Engineering Change Request		ECR Number	R10442W
Initiator:	Aaron	Date:	2026.7.1
Part number description			
Reason of change:			
<input type="checkbox"/> Customer requirement (list the feasibility analysis of customer specification: _____)			
<input type="checkbox"/> Supplier request (list the PCR number: _____)			
<input checked="" type="checkbox"/> internal improvement <input type="checkbox"/> corrective <input type="checkbox"/> other			
Please describe here in detail:			
<p>Optimize the female pin assembly process by changing the construction from assembled type to integrated one-piece structure. The modification exerts no adverse impact on product assembly and electrical performance. (HVSL1200 Series)</p>			
Change level and impact assessment (Please tick in the appropriate position)			
Change level	Change content	Whether to notify the customer	
Level 1	<input type="checkbox"/> Operator change	<input type="checkbox"/> It is not necessary to notify the customer for approval

Optimize the female pin assembly process by changing the construction from assembled type to integrated one piece structure. The modification exerts no adverse impact on product assembly and electrical perform

Assembled type structure

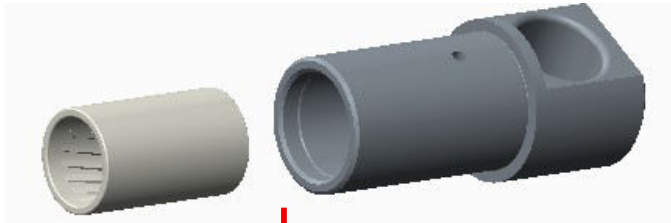
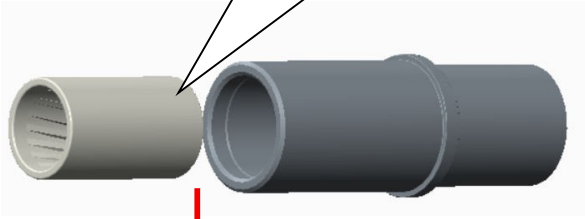
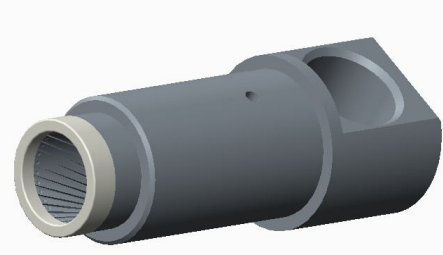
Before change

After change

Monolithic construction
